## Access Compliance Report Public Rights-of-Way (Curb Ramps)

Intersection ID: 10032242 Main Street: MOSS\_RD Cross Street: N/A Location: NE

ADA ID: 24BFB430D276 Ramp Type: PerpDiag Initial Pass/Fail: Fail Overall Compliance: No Severity Score: 12.5

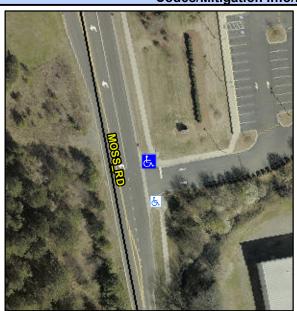
Not Found, R304.2.2

Compliance Description		Data	Compliance Description		Data
N/A	Ramp Length (in)	30.0	No	Ramp Slope (%)	9.3
Yes	Ramp Width (in)	48.0	Yes	Ramp XSlope (%)	1.5
N/A	Flare Type LT	N/A	N/A	Flare Type RT	N/A
N/A	Flare Slope LT (%)	N/A	N/A	Flare Slope RT (%)	N/A
N/A	Flare Traversable LT?	N/A	N/A	Flare Traversable RT?	N/A
N/A	Landing Length (in)	N/A	N/A	DWS Provided?	N/A
N/A	Landing Width (in)	N/A	N/A	DWS Contrast?	N/A
N/A	Landing Slope (%)	N/A	N/A	DWS Length (in)	N/A
N/A	Landing X Slope (%)	N/A	N/A	DWS Full Width?	N/A
N/A	Landing Curb? (Y/N)	N/A	N/A	DWS Offset (in)	N/A
N/A	Shared Landing?	N/A			
N/A	Gutter Ponding?	N/A	N/A	Gutter Slope (%)	N/A
N/A	Gutter Lip Ht (in)	N/A	N/A	Gutter X Slope (%)	N/A
N/A	Painted X Walk1?	No	N/A	Painted X Walk2?	No
	X Walk 1 Direction	To W		X Walk 2 Direction	To S
N/A	X Walk 1 Width (in)	N/A	N/A	X Walk 2 Width (in)	N/A
	X Walk 1 Slope (%)	8.9		X Walk 2 Slope (%)	1.0
	X Walk 1 X Slope (%)	7.1		X Walk 2 X Slope (%)	4.8

Remove & Replace Curb Ramp With
Two New Directional Ramps or
Equivalent.
